Product Change Notification / ALAN-11ELYX284

CCB 4768 Final Notice: Qualification of ANAP as an additional assembly site for selected Atmel ATSAMG55J19A and ATSAMG55J19B device families available in 64L LQFP (10x10x1.4mm) package.

CCB 4768
Pre and Post Change Summary
PCN# ALAN-11ELYX284

Pre Change

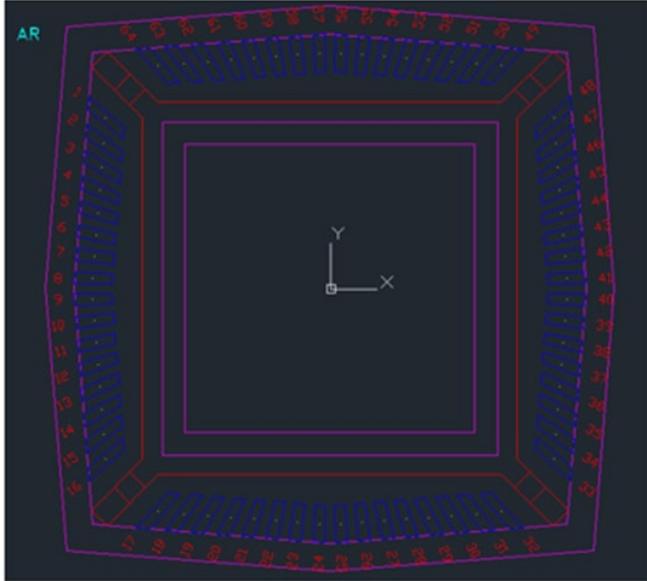
Assembly location

ASE Inc. (ASE)

Lead frame material

C7025

Lead frame paddle size

200x200 mils

Post Change

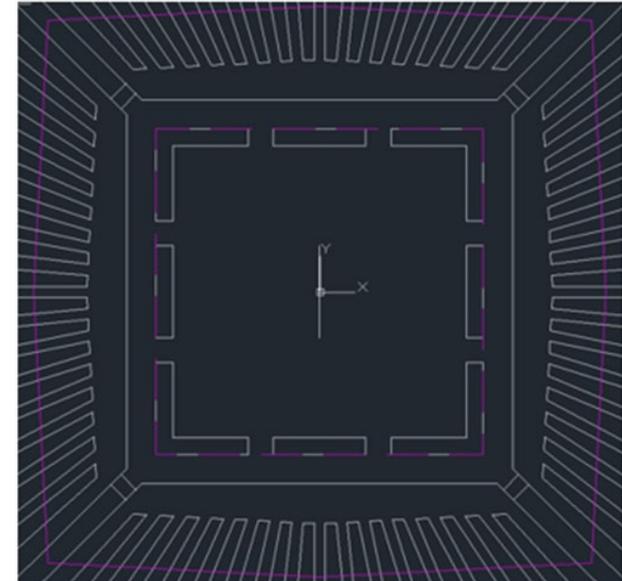
Assembly location

Amkor Technology Philippine
(P1/P2), INC. (ANAP)

Lead frame material

C194

Lead frame paddle size

138x138 mils
